Access Compliance Report

Public Rights-of-Way

Intersection ID: 23117	Main Street: CEDAR_CROSSINGS_DR	Cross Street: ERWIN_RD	Location: E
ADA ID: FDD8410FB0DC	Ramp Type: PerpDiag	Initial Pass/Fail: Fail	Overall Compliance: No
		Severity Score: 25

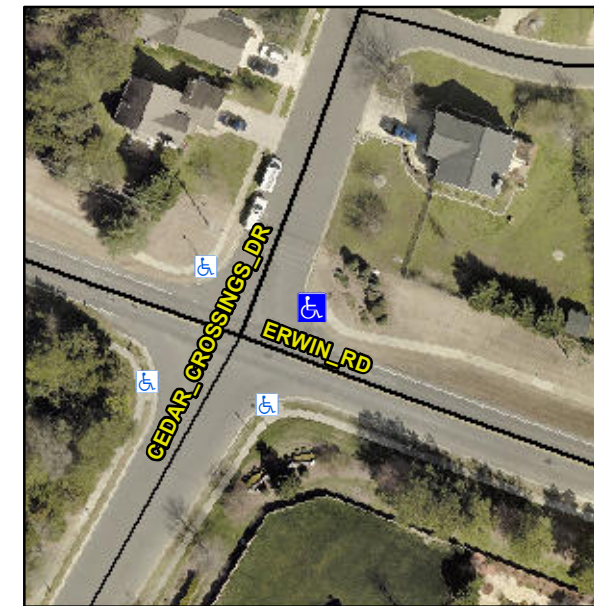
Compliance	Description	Data	Compliance	Description	Data
N/A	Ramp Length (in)	111.0	No	Ramp Slope (%)	12.7
Yes	Ramp Width (in)	48.0	Yes	Ramp XSlope (%)	0.1
N/A	Flare Type LT	N/A	N/A	Flare Type RT	N/A
N/A	Flare Slope LT (%)	N/A	N/A	Flare Slope RT (%)	N/A
N/A	Flare Traversable LT?	N/A	N/A	Flare Traversable RT?	N/A
N/A	Landing Length (in)	N/A	N/A	DWS Provided?	N/A
N/A	Landing Width (in)	N/A	N/A	DWS Contrast?	N/A
N/A	Landing Slope (%)	N/A	N/A	DWS Length (in)	N/A
N/A	Landing X Slope (%)	N/A	N/A	DWS Full Width?	N/A
N/A	Landing Curb? (Y/N)	N/A	N/A	DWS Offset (in)	N/A
N/A	Shared Landing?	N/A			
N/A	Gutter Ponding?	N/A	N/A	Gutter Slope (%)	N/A
N/A	Gutter Lip Ht (in)	N/A	N/A	Gutter X Slope (%)	N/A
N/A	Painted X Walk1?	No	N/A	Painted X Walk2?	No
	X Walk 1 Direction	To NW		X Walk 2 Direction	To SW
N/A	X Walk 1 Width (in)	N/A	N/A	X Walk 2 Width (in)	N/A
	X Walk 1 Slope (%)	2.2		X Walk 2 Slope (%)	1.2
	X Walk 1 X Slope (%)	2.5		X Walk 2 X Slope (%)	0.4

Remove & Replace Curb Ramp With Two New Directional Ramps or Equivalent.
